Memorandum

TO: Queensland Floods Commission of Inquiry
FROM: Mark Babister
DATE: 7 October 2011
SUBJECT: Response to Peer Reviews of WMAwater's *Brisbane River 2011 Flood Event - Flood Frequency Analysis* (Sept 2011)
PROJECT NUMBER: 111024

Port Office - Pre and Post Dam (Updated Figure 3)

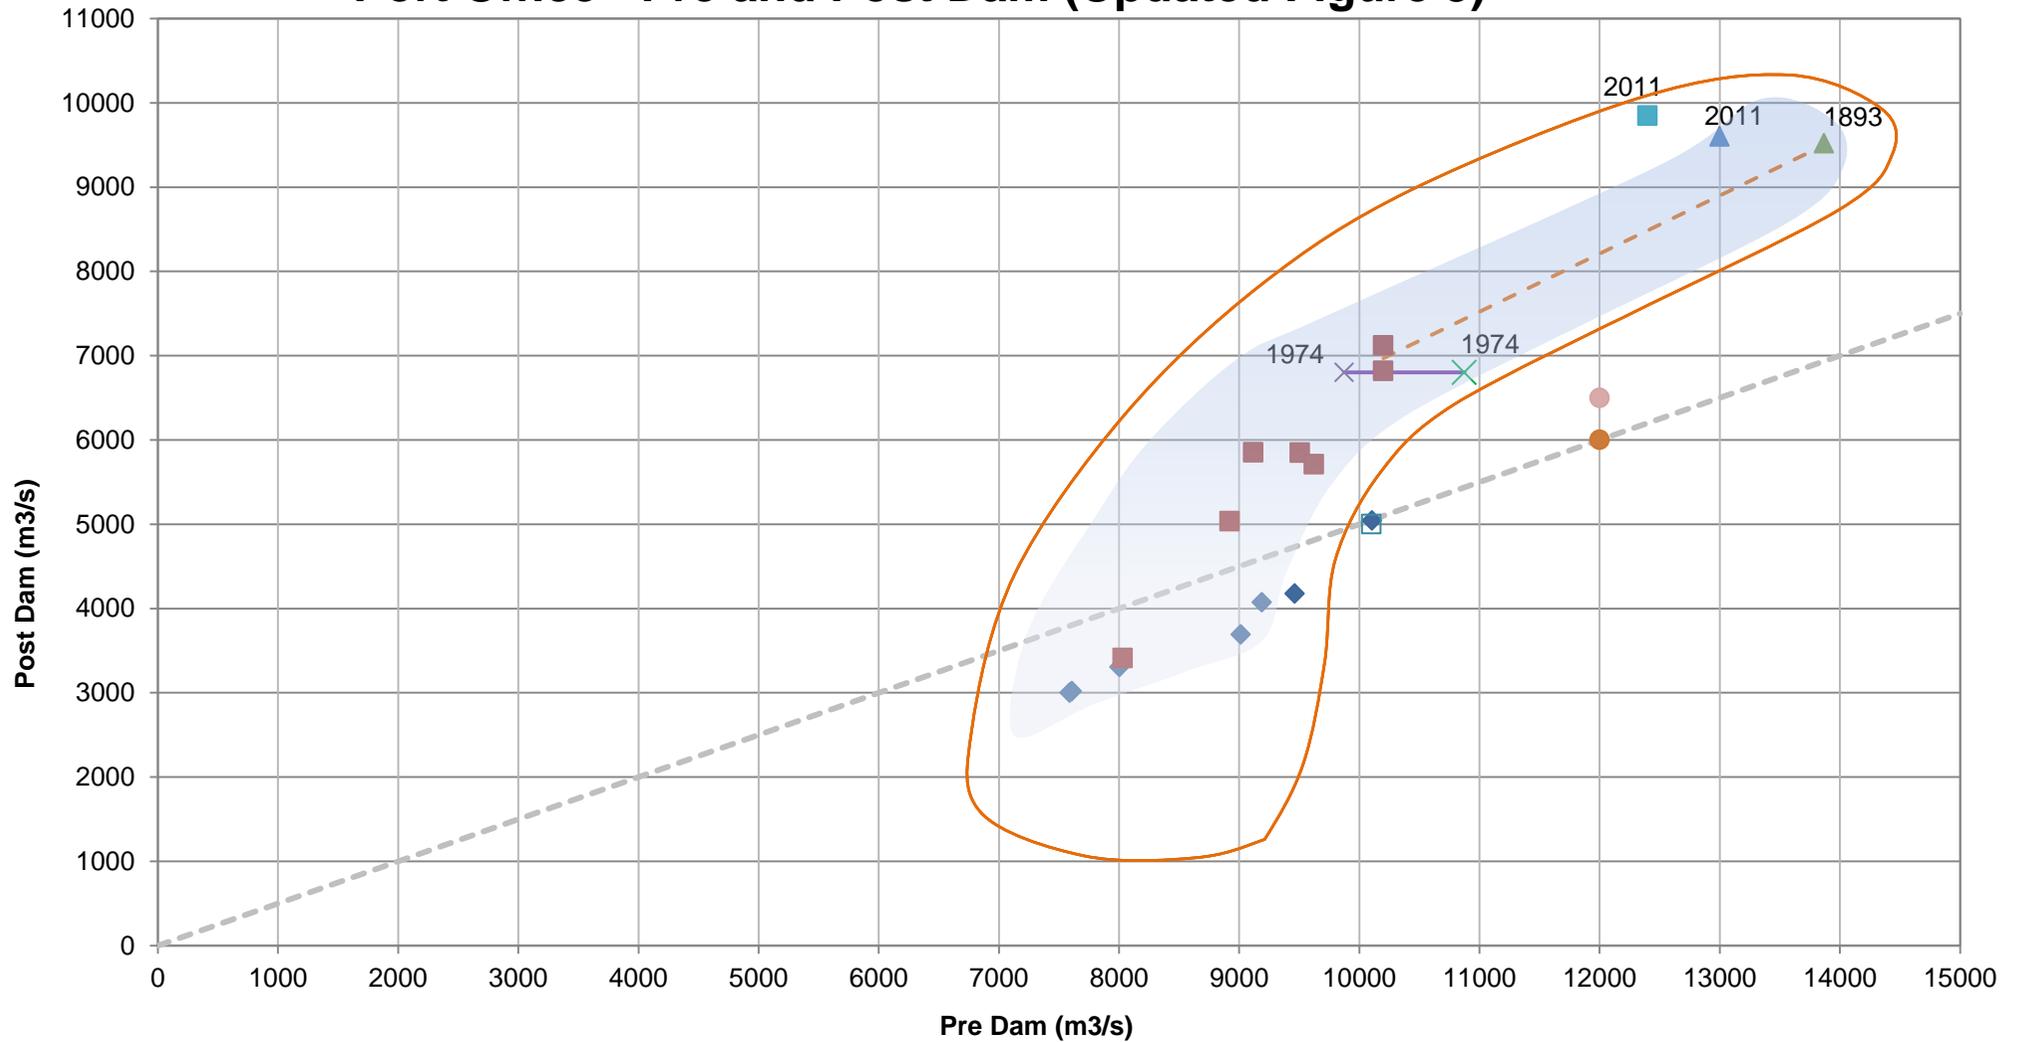
- 12 Using models it would be possible to add additional data points to these graphs. This would be best done by using a range of design rainfalls with observed temporal patterns and appropriately scaled spatial distributions. If the graph were sufficiently populated it could be used as part of a joint probability exercise to determine post dam flows from pre dam flows. The variability seen on these graphs represents the influence of many of the factors discussed by Dr Nathan in Paragraph 37 Reference 11. When the data points on these graphs are considered as hydrologic loadings there is no “circular” argument as suggested by Dr Nathan (Reference 11, paragraph 19, 55).

- 13 The 3 historical events (1893, 1974 and 2011) on Figure 3 are described by Dr Nathan as a “miserably small” dataset, they show a dam performance which is very different from the 2003 Review Panels 12 000 m³/s pre dam to 6000 m³/s post dam (Reference 5) and SKM (2003) 12 000 m³/s pre dam to 6500 m³/s post dam and all 3 events are larger than 6500 m³/s. This raises serious concerns about the 2003 pre to post dam conversion as not one historical event supports it and it is hard to accept all 3 events are outliers.

- 9 The intent of these figures was to demonstrate the variability of pre dam to post dam flows and that there is no fixed ratio as this will vary from one event to the next. It was for this reason that the approximate zone of influence (solid orange line) was drawn around these values. The key aspect of Figures 2 – 5 (Reference 9) is that they include the best estimates of 1893, 1974 and 2011 events, as well as a number of synthetic (design) events. An updated version of Figure 3 is attached which includes a range of plausible adjustments for the impact of Somerset dam. It also shows the most likely zone of influence based on the scatter of the data points.

- 10 Figure 2 mainly contains Seqwater (Reference 12) and DNR data, while nearly all the points on Figures 3 - 5 were extracted from modelling work carried out by SKM (Reference 6). Even though Figure 2 is derived from different data sets it has a very similar shape to Figures 3 - 5.

- 15 Dr Leonard (Reference 10) has suggested that we have used implicit knowledge of the 2011 event to estimate post dam Q100 flow. While we were clearly aware of the dams impact on the 2011 event we believe that the estimate is valid without being aware of this event and makes best use of

the behaviour of large events that were known prior to 2011 (orange dashed line (estimation line) on Figure 3).
